**Bulletin**

MODEL: BENTLEY MARK VI

MODIFICATION.FOR CATEGORY 2 ACTION:REAR BUMPER SUPPORT BRACKETS.

REAR SHOCK ABSORBER LINKAGE.

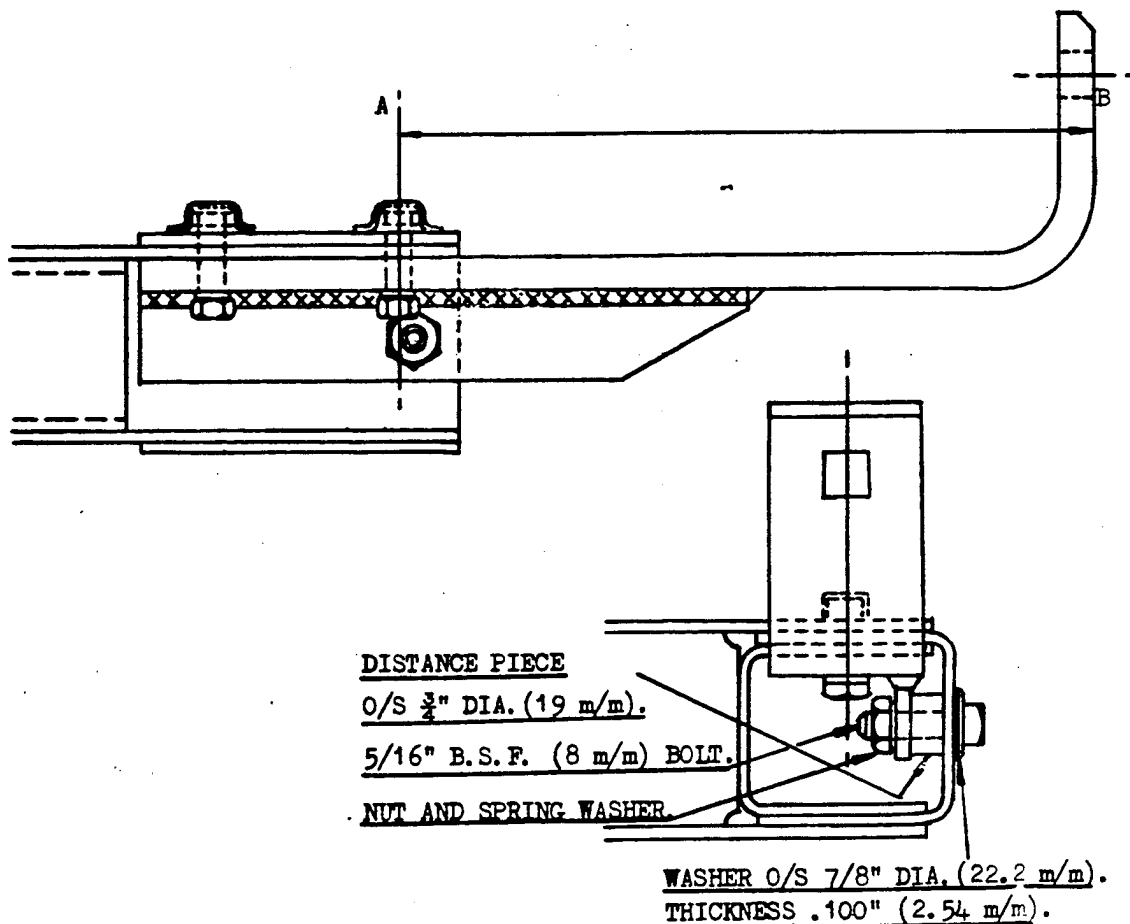
Owing to the fact that the rear shock absorber linkage is assembled and tightened up at the chassis stage, the angle of the connecting link differs considerably from its position when normally loaded with the body, and a permanent strain is imposed on the silentbloc bushes when in the normal operating position.

In order to relieve this strain, the present method of assembly is to leave the final tightening of the silentbloc bushes until the car is normally laden with the body, and in order to ensure that this condition applies to cars already in service, it has been decided to take action on existing cars when they are available at Service Depots by slacking off the silentbloc fixing bolt at the lower end of the forked connecting link between the shock absorber arm and the knuckle joint on the axle. After slacking off, the car should be bounced a few times and allowed to settle in the normally loaded state, after which the bolts should be retightened.

When retightening, it should be observed that the silentbloc at the extreme lower end, i.e. the one pointing forward, is free from strain. If the strain has not been released properly, the spindle to which the silentbloc is fixed will appear to be tilted relative to the knuckle joint. This condition should not exist in the normally laden position.

MODIFICATION.For Category 2 Action:REAR SHOCK DAMPER LINKS.

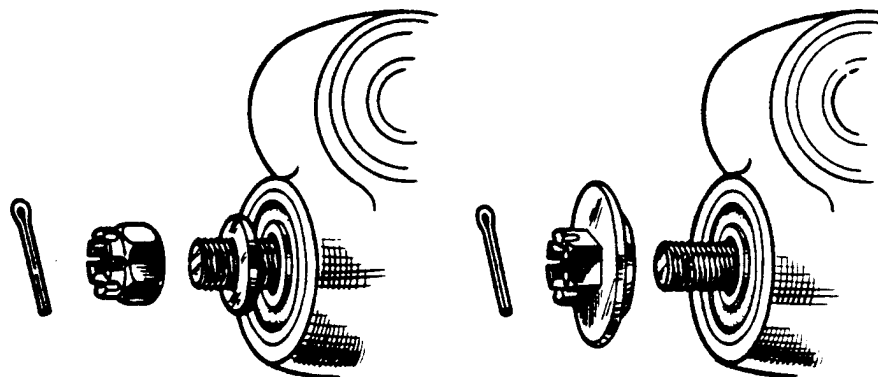
A modified type of retaining nut is now specified for the Silentbloc bush which connects the rear spring pad stud to the shock absorber linkage. The new nut has a flange, the diameter of which is greater than the bore of the knuckle into which the bush is fitted.

It is intended that this flange should act as a safety device to prevent the shock absorber linkage becoming detached from the spring pad stud, if severe road conditions cause the Silentbloc bush rubber to shift in its housing.

Fig. 1. Parts to convert Standard cars

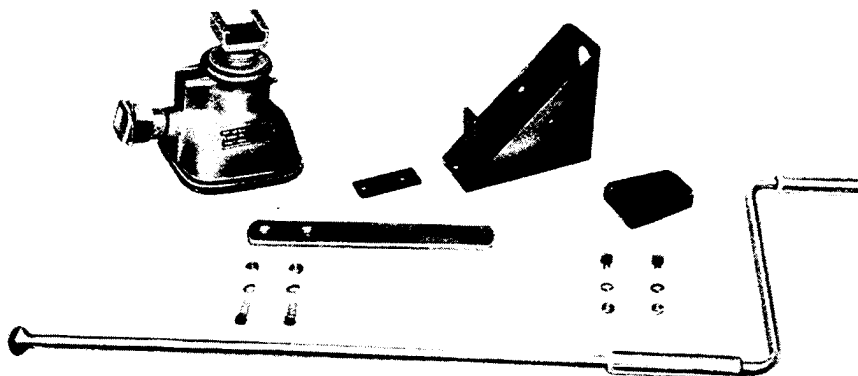
In order that the Dunlop jack may be used, the two existing 3rd body mounting brackets must be removed from the chassis and replaced by the later type of mounting bracket (RF.6007). This bracket is provided with a slide bar adaptor which is welded in position on the bracket.

Shown in Figure 1 are the material requirements necessary to convert one of the two 3rd. body mounting brackets; also shown are the Dunlop jack and handle.

Fig. 2. Dimensions for fitting Support Brackets and Slide Bars

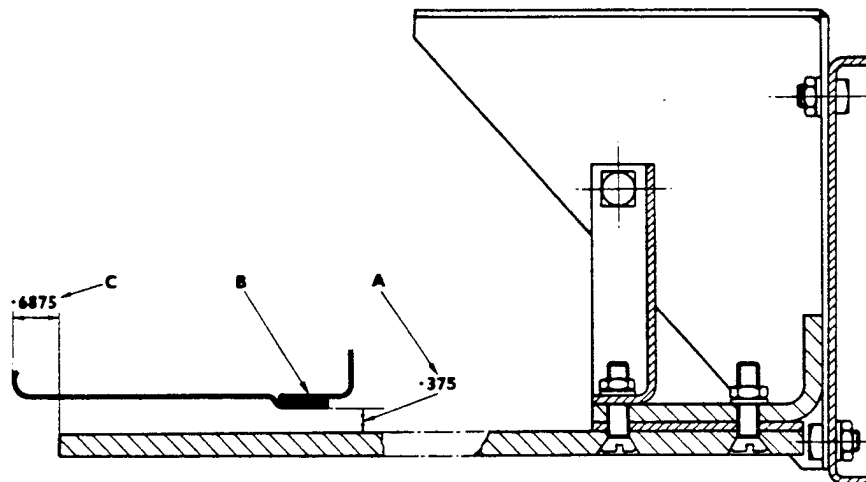
The support brackets (RF.6011) and the slide bars (RF.6015) may then be fitted to the body mounting brackets, as shown in Figure 2. Packing plates (RF.6013) should be placed between the slide bars and the body mounting brackets to give a clearance of 0.375 in. between the slide bar and the underside of the sill as shown by measurement A in Figure 2. The 0.750 in. deep flange on the underside of the sill (see B. Fig.2) should be flattened for a minimum distance of 2.000 in. on either side of the centre line of the slide bar.

Fig. 3. Stowage of Jack

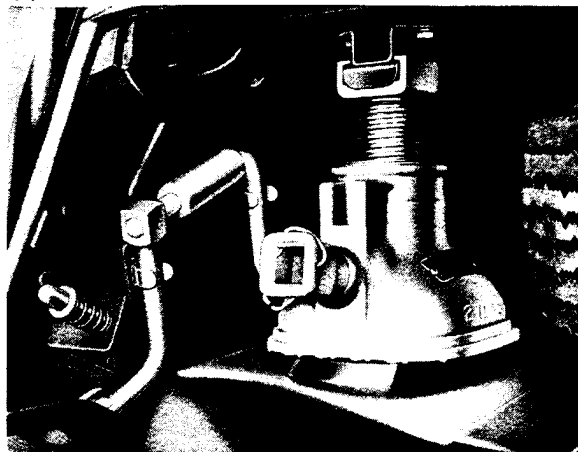
Figure 3 shows the Dunlop jack stowed in the spare wheel compartment on the left-hand side of the spare wheel. The wedge shaped wood block (RW.2340), on which the jack stands, is fitted so that its thinner end butts against the transverse rib of the floor (see A. Fig.5) and its left-hand edge is 3.125 in. from the wall of the spare wheel compartment (see B. Fig.5). The wedge is secured to the floor by two countersunk screws; these are of different lengths to allow for the variation in the thickness of the wood block.

Fig. 4. Dimensions for fitting Upper Support

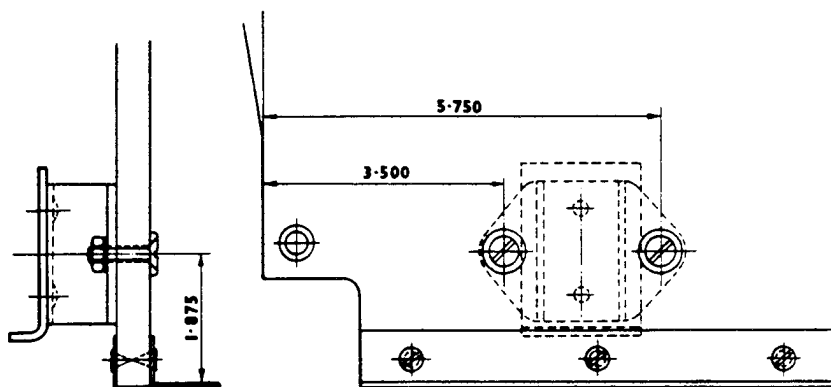
The upper support (327/257) for the jack should be fitted to the underside of the luggage floor, working to the dimensions shown in Figure 4 so that the upper support lip is facing towards the rear of the car (see Fig.5).

Fig. 6. Fitting of Jack Handle Clips

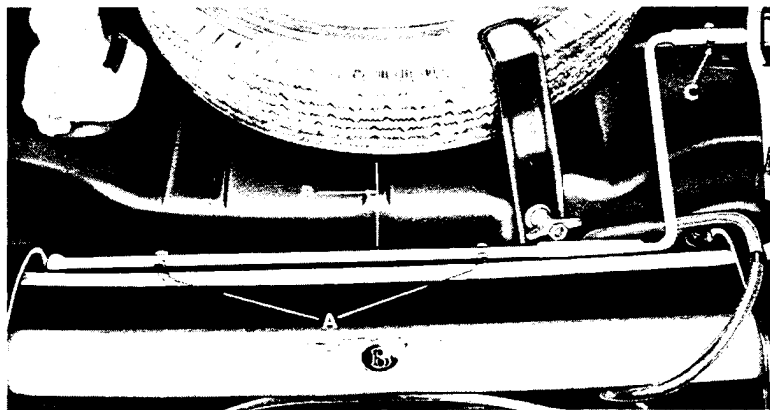
Remove the Bevelift jack clips from the well of the spare wheel compartment in order that the two rear jack handle support assemblies (327/256) may be fitted.

Detach the lower boot door sealing rubber at the two points marked 'A' in Figure 6, sufficiently to enable two 4BA clearance holes to be drilled through the sealing rubber securing flange. Taking the centre of the stiffening rib of the spare wheel compartment floor as a datum line (see B. Fig.6) drill the two clearance holes at points 10 in. to the left and 4.500 in. to the right of the datum line. Secure the two jack handle rear supports in position with two 4BA screws and nuts, using the two upper holes in the supports. The countersunk heads of the screws should be on the outer side of the sealing rubber securing flange. Refit the rubber seal. Using the two lower holes in the support brackets as guides, drill two 3BA clearance holes through the floor of the well at the rear of the spare wheel compartment, then secure the rear supports with two 3BA screws and nuts.

Fit the jack handle in position in the two rear supports and clip the front support (327/258) to the centre of the jack handle grip (see C. Fig.6). Lay the handle grip on the floor of the spare wheel compartment, then using

Fig. 7. Parts to convert Coach-built Cars

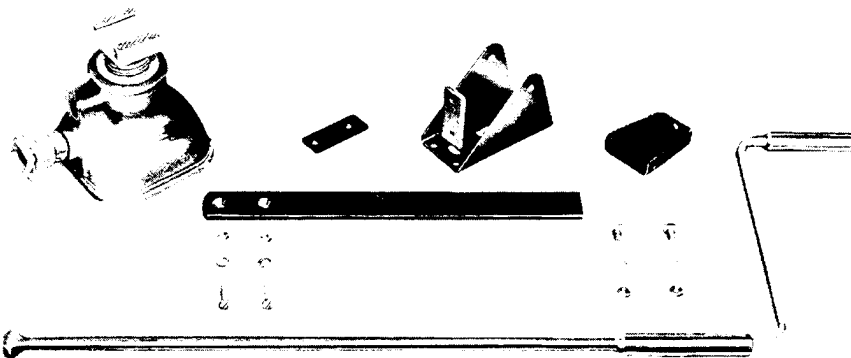
The procedure adopted for converting the jacking system on coachbuilt cars is basically the same as for the standard body. The conversion should be carried out in the same manner except where stated otherwise in the following paragraphs. Figure 7 shows the material requirements necessary to convert one of the jacking brackets; also shown are the Dunlop jack and handle.

Fig. 8. Dimensions for fitting Support Brackets and Slide Bars

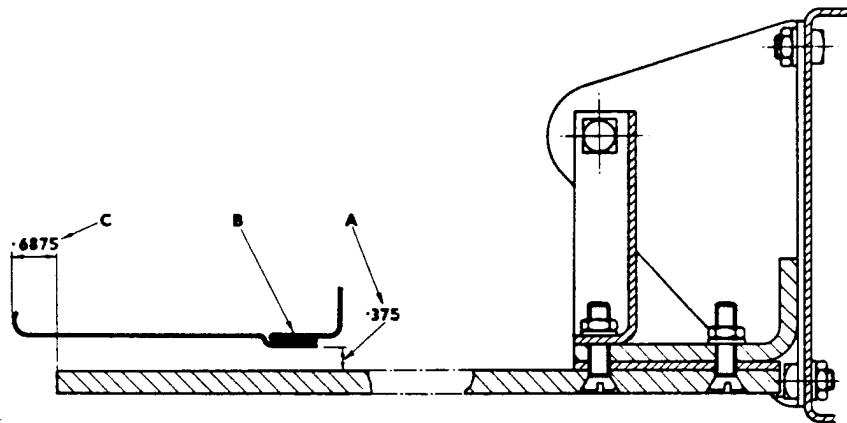
The jacking brackets used on coachbuilt cars do not act as body mounting brackets, therefore the operation of removing the existing Bevelift jacking brackets and fitting the later type brackets (RF.6009) is greatly simplified. Fit the brackets as described previously. When fitting the slide bar, it may be necessary to trim the end of it in order to obtain the correct clearance between the edge of the sill and the end of the slide bar. (see C. Fig.8).
